Access Compliance Report

Public Rights-of-Way

(Curb Ramps)

Intersection ID: 20224	Main Street: DINGESS_RD	Cross Street: KEARNEY_CT	Location: NW
ADA ID: B5F5A47E25EF	Ramp Type: PerpDiag	Initial Pass/Fail: Fail	Overall Compliance: No
Severity Score: 48.75			
Codes/Mitigation Info/Possible Solution		Field Measurements/Component Compliance

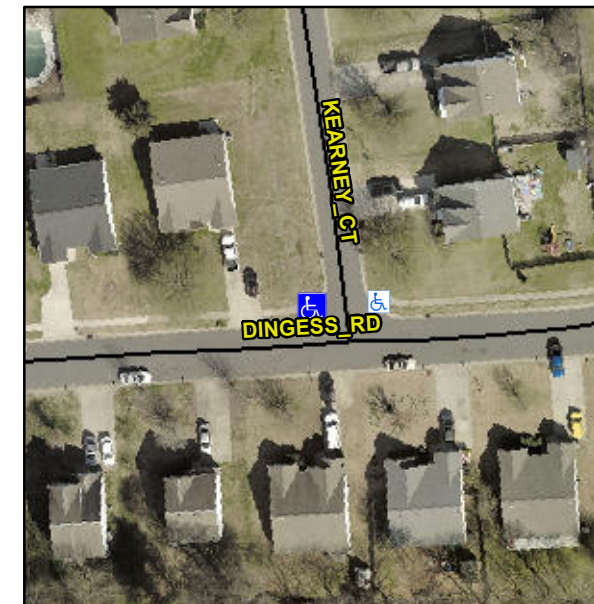
Not Found, R304.5.1, R304.2.2, R304.5.3

Compliance	Description	Data	Compliance	Description	Data
N/A	Ramp Length (in)	47.0	No	Ramp Slope (%)	8.5
No	Ramp Width (in)	25.0	No	Ramp XSlope (%)	2.1
N/A	Flare Type LT	N/A	N/A	Flare Type RT	N/A
N/A	Flare Slope LT (%)	N/A	N/A	Flare Slope RT (%)	N/A
N/A	Flare Traversable LT?	N/A	N/A	Flare Traversable RT?	N/A
N/A	Landing Length (in)	N/A	N/A	DWS Provided?	N/A
N/A	Landing Width (in)	N/A	N/A	DWS Contrast?	N/A
N/A	Landing Slope (%)	N/A	N/A	DWS Length (in)	N/A
N/A	Landing X Slope (%)	N/A	N/A	DWS Full Width?	N/A
N/A	Landing Curb? (Y/N)	N/A	N/A	DWS Offset (in)	N/A
N/A	Shared Landing?	N/A			
N/A	Gutter Ponding?	N/A	N/A	Gutter Slope (%)	N/A
N/A	Gutter Lip Ht (in)	N/A	N/A	Gutter X Slope (%)	N/A
N/A	Painted X Walk1?	No	N/A	Painted X Walk2?	No
	X Walk 1 Direction	To S		X Walk 2 Direction	To E
N/A	X Walk 1 Width (in)	N/A	N/A	X Walk 2 Width (in)	N/A
	X Walk 1 Slope (%)	3.4		X Walk 2 Slope (%)	5.2
	X Walk 1 X Slope (%)	3.7		X Walk 2 X Slope (%)	2.2

Remove & Replace Curb Ramp With Two New Directional Ramps or Equivalent.
